FIRE SAFETY INSPECTION REPORT

ENVOY FASHION LTD.

DIAKHALI, YEARPUR, JAMGORA, SAVAR, DHAKA.

March 30, 2014

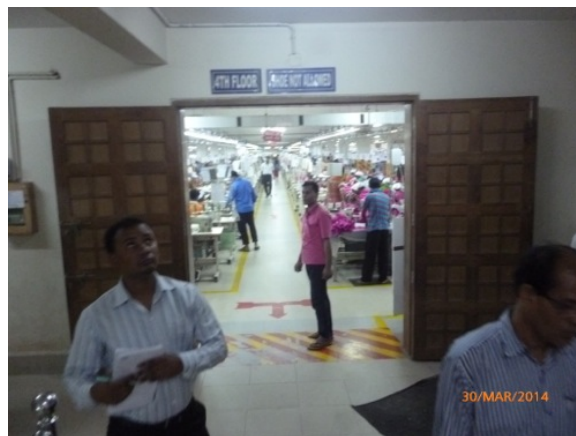
F-2	Fire Rated Construction	Areas used for combustible storage are not separated by fire-rated construction. Location: Ground floor-General storage, Fabric storage. 3rd and 5th floor east stairwell. 3rd floor production area.	Provide dedicated storage rooms separated by minimum 1-hr fire-rated construction. Storage maximum height of 2.4m and maximum area of 23m2	Within 3 months

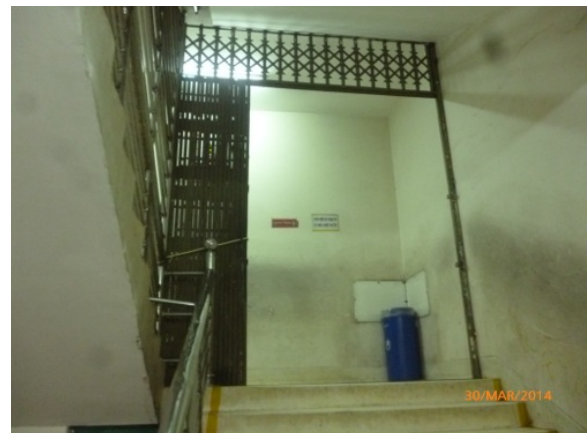
F-5	Egress	Egress doors and gates with locking features are provided at building exits, exit stairs and exit discharge. All gates and doors were open and unlocked during the inspection.	Remove locking features from all egress doors / gates. If locks are required for security reasons, utilize special door locking features complying with NFPA 101.	Immediate
-----	--------	--	---	-----------

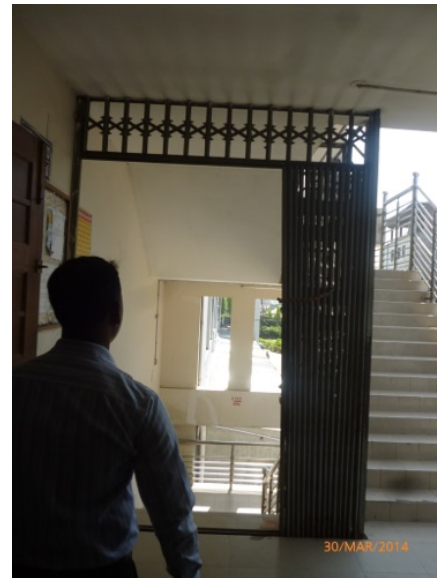
F-8	Egress	Collapsible gates and sliding doors are provided at building exits, exit stairs and exit discharge.	Replace all gates and sliding doors along the means of egress with side-hinged, swinging egress doors. If locks are required for security reasons, utilize special door locking features complying with NFPA 101.	Within 1 month
-----	--------	---	--	----------------
